Re: HECA Updated Emissions and Modeling Report

HYDROGEN ENERGY CALIFORNIA KERN COUNTY, CALIFORNIA

UPDATED EMISSIONS AND MODELING REPORT

REVISED FIGURE 1-1

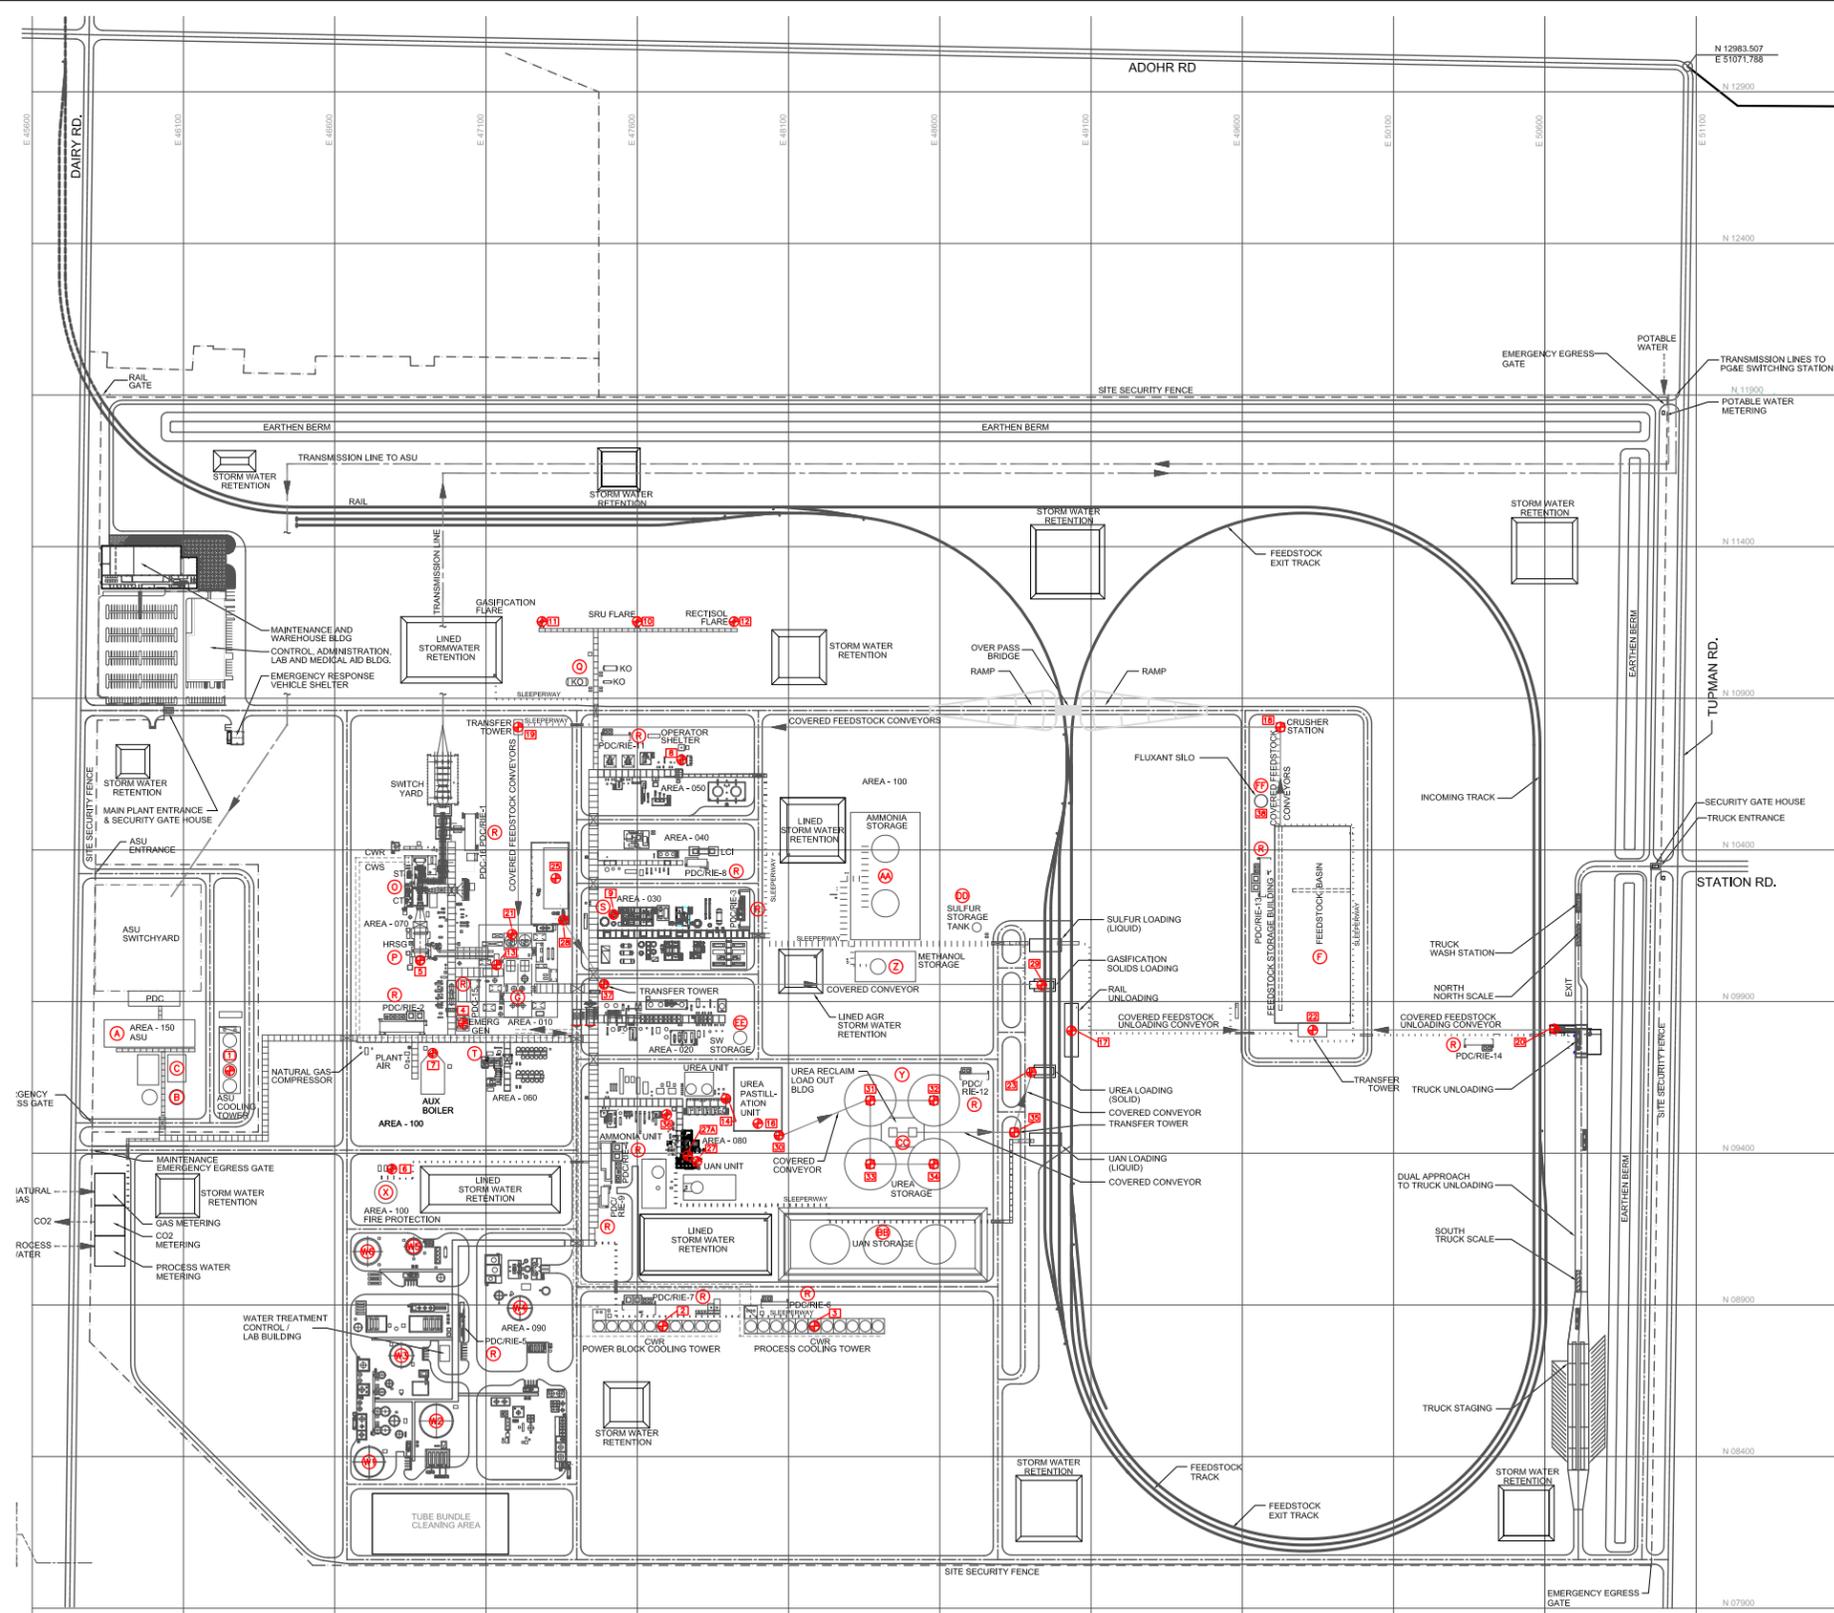
The coordinates of the fence around the Controlled Area were moved slightly in toward the center of the Project Site to ensure adequate roadway easement. The fences along Station, Adohr, and Dairy roads were affected. Boundaries of the Project Site and Controlled Area are shown on Revised Figure 1-1, Project Site Plan and Vicinity.

The Project Controlled Area boundary was moved slightly to ensure adequate roadway easements; thus, the boundary along Station, Adohr, and Dairy roads was affected. Receptors were placed along the new property line using the same methodology as given in the ATC/PSD Application. The property line extends around the perimeter of the Project Site and Controlled Area (see Revised Figure 1-1).

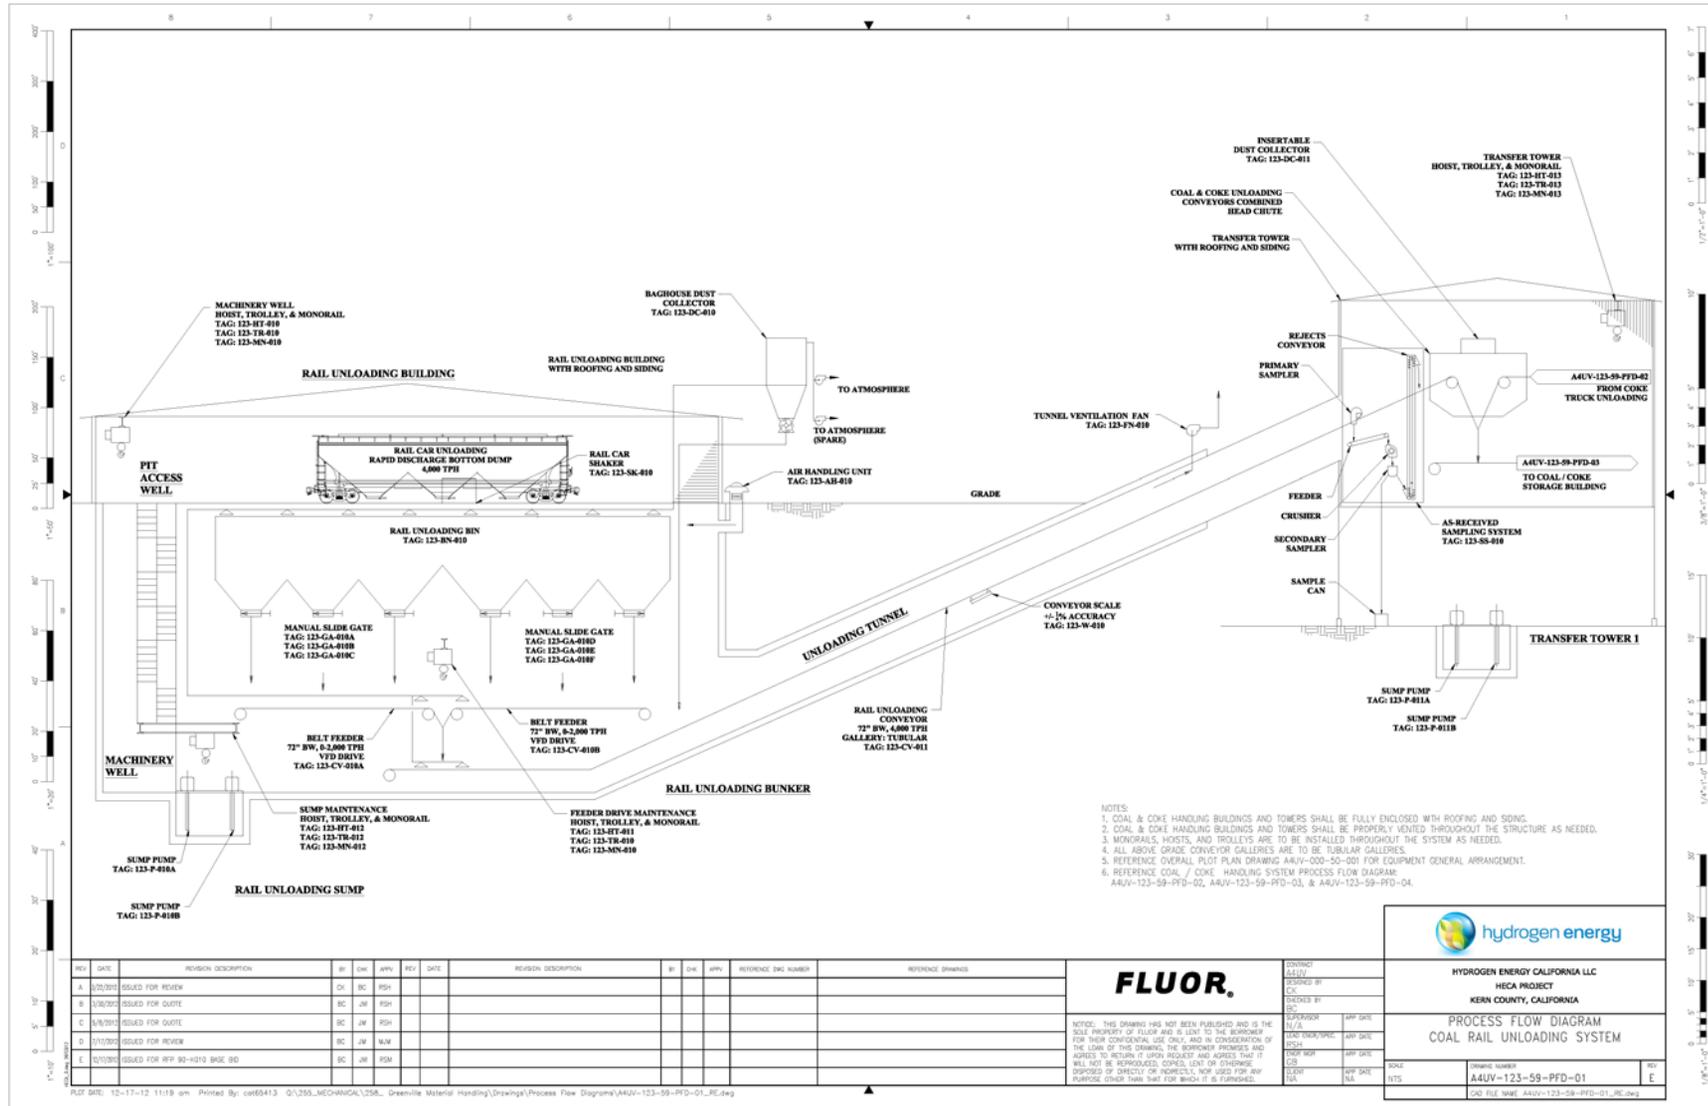
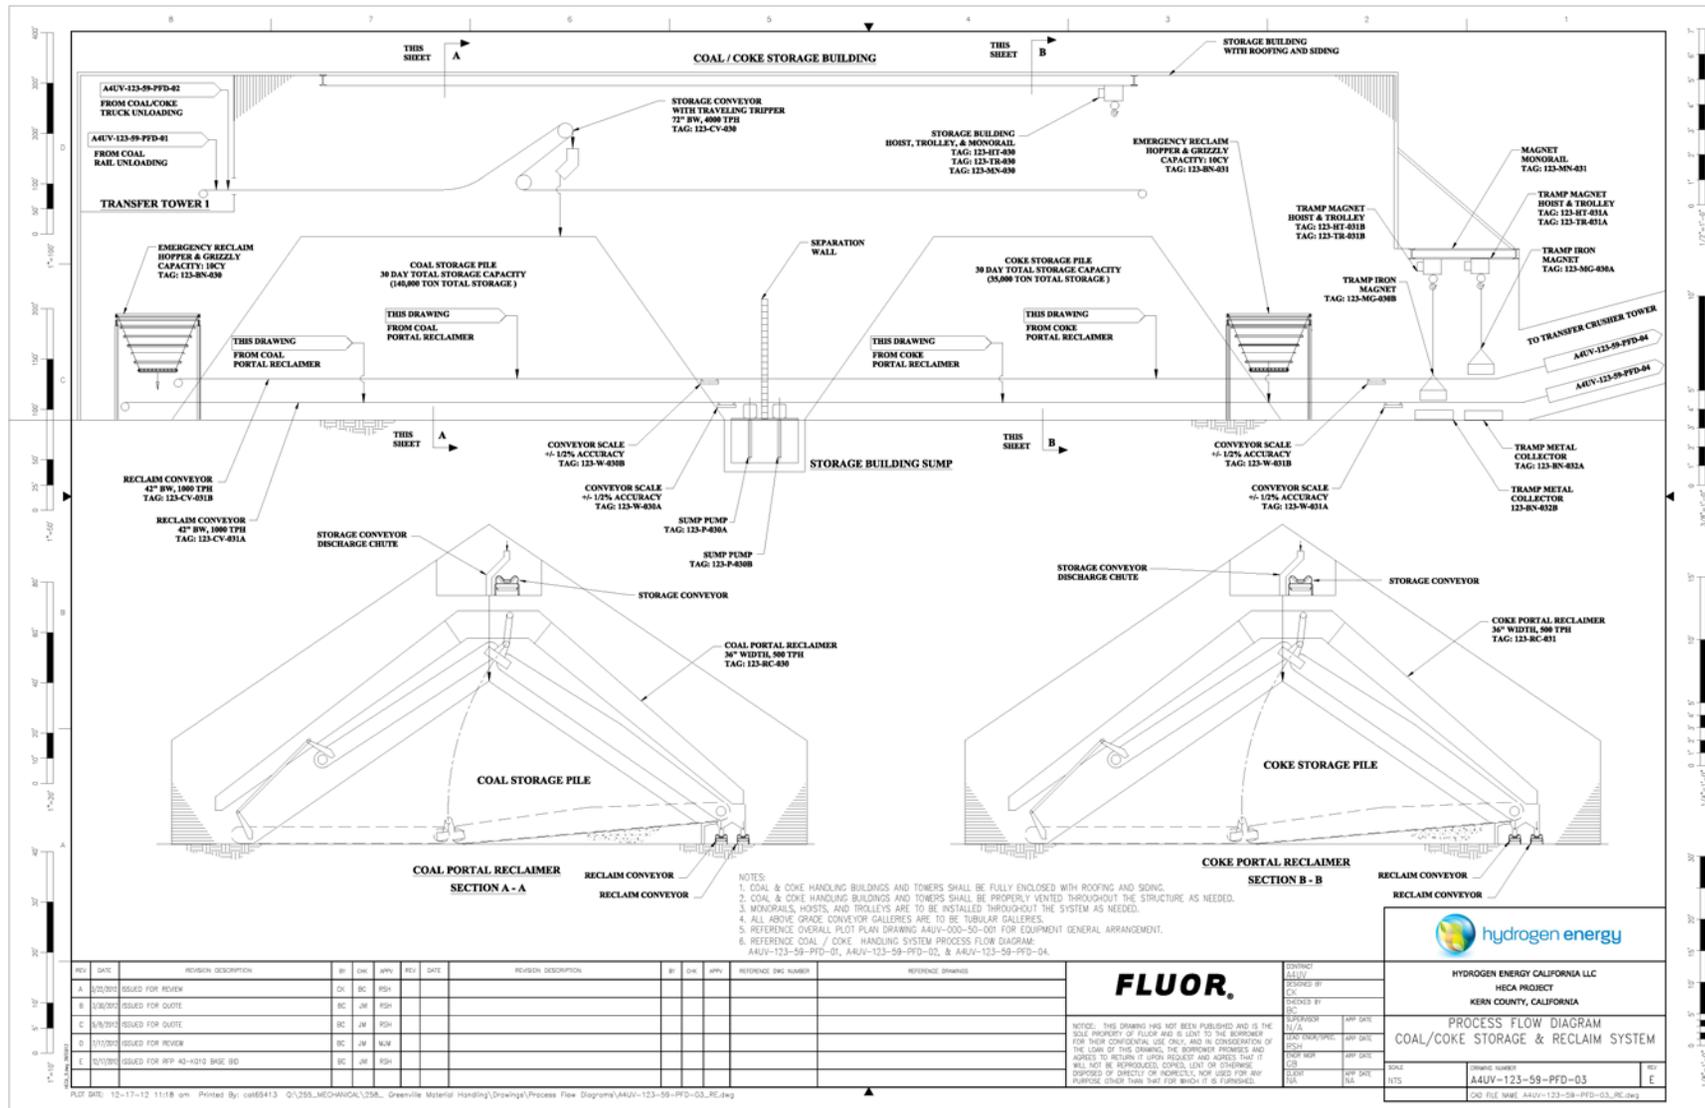
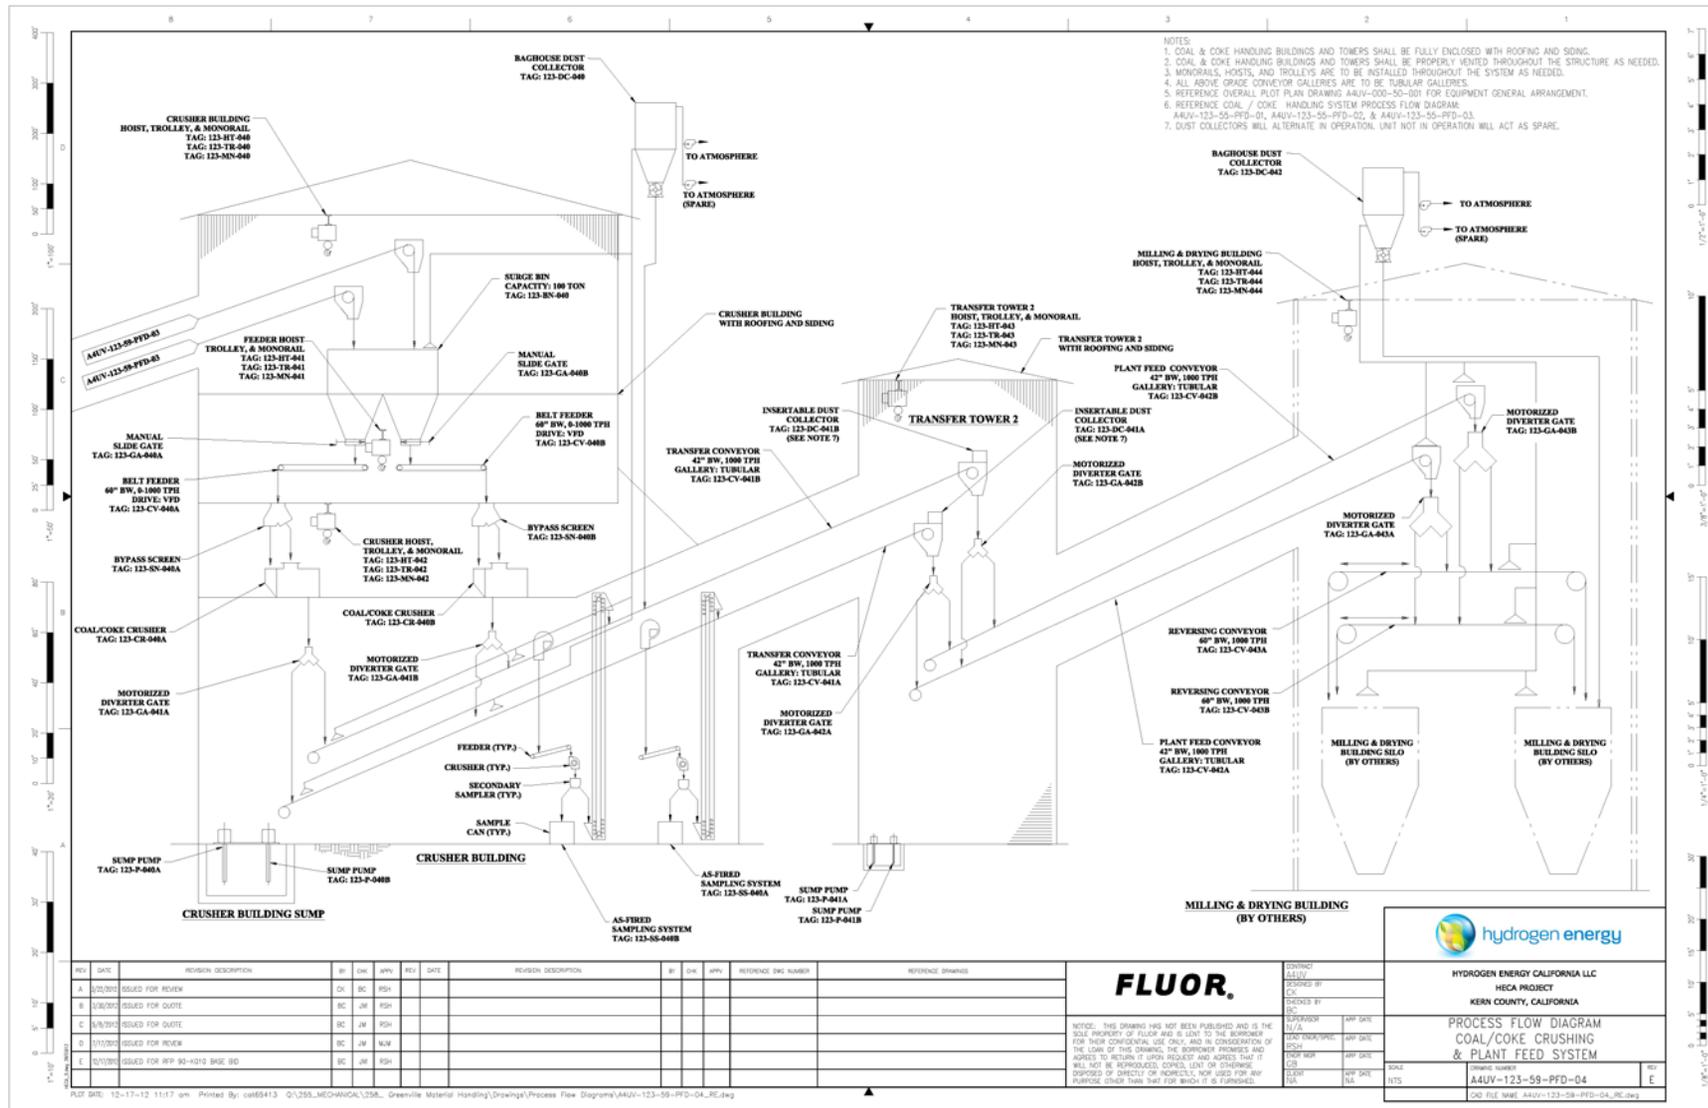
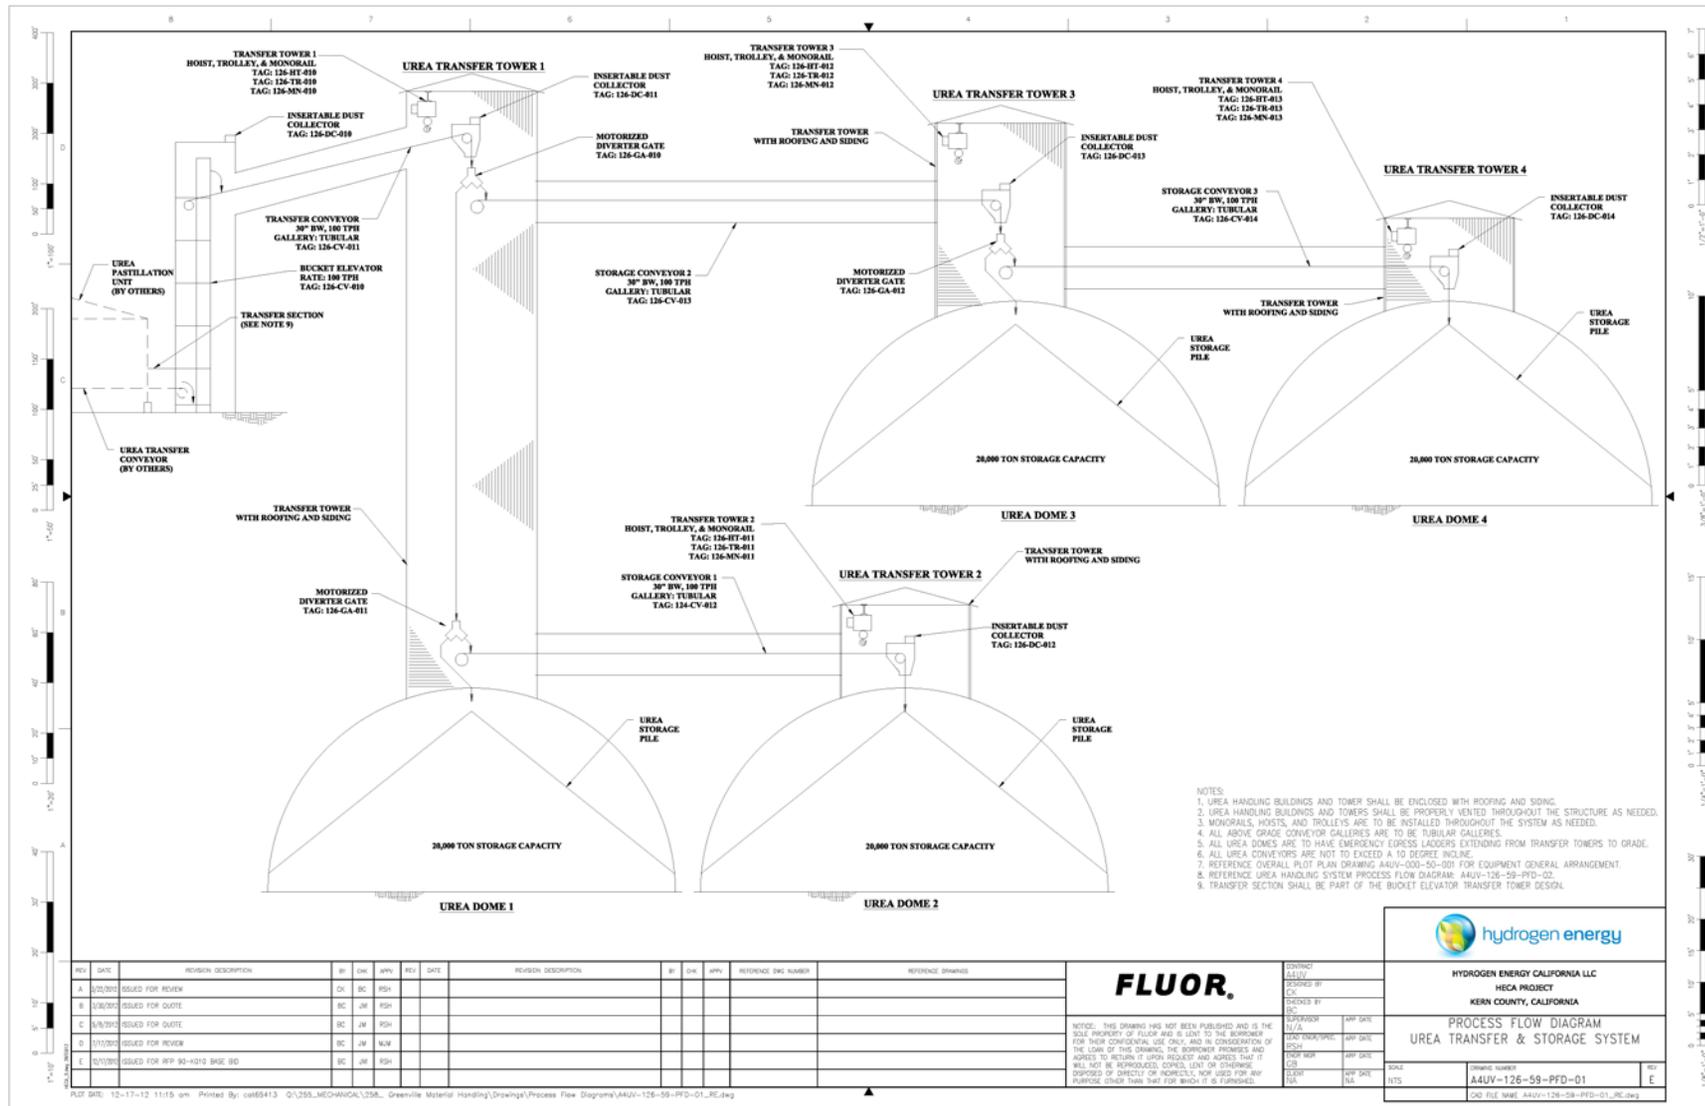
Updated process flow diagrams show the material handling system. Only the feedstock crusher vent and feedstock transfer tower 2 switched locations; now the crusher station is closer to the feedstock barn (Figures 3-1 through 3-4). Although these do not show the fluxant handling system, there will be a baghouse that services the fluxant unloading and storage silo. The fluxant will be blended with the feedstock when it leaves the northern side of the feedstock barn.
